## ADVERTISED COPY

1 July 2022

### **TPA/52240 - 580 SPRINGVALE ROAD, WHEELERS HILL MIXED USE DEVELOPMENT – BRANDON PARK SHOPPING CENTRE SECTION 57A AMENDMENT**

**Figure 2 – Proposed landscaping within the setback to Brandon Park Drive**  
**Source: SLS Landscape Concept Plan**

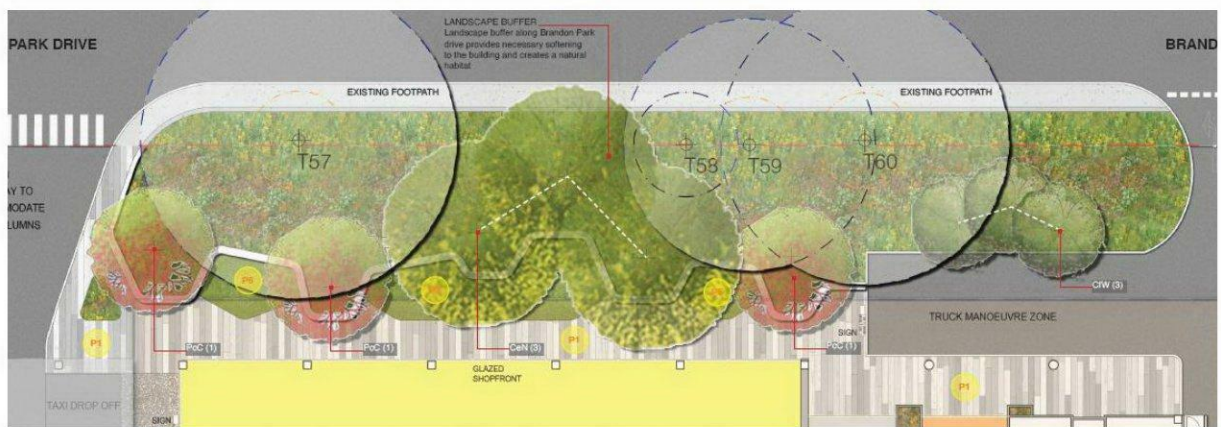
The deletion of the porte cochere lane within the front setback of the site has significantly improved the landscaping capabilities of the site, now providing a 10.40m wide landscaped area along the majority of the frontage, which reduces to 7m in width at the southern end of the frontage. The enclosed amended Landscape Concept Plan depicts the manner in which this dedicated landscaped area can accommodate retention of existing trees, plus generous planting of new trees within the street setback to provide a strong vegetated buffer to Brandon Park Drive.
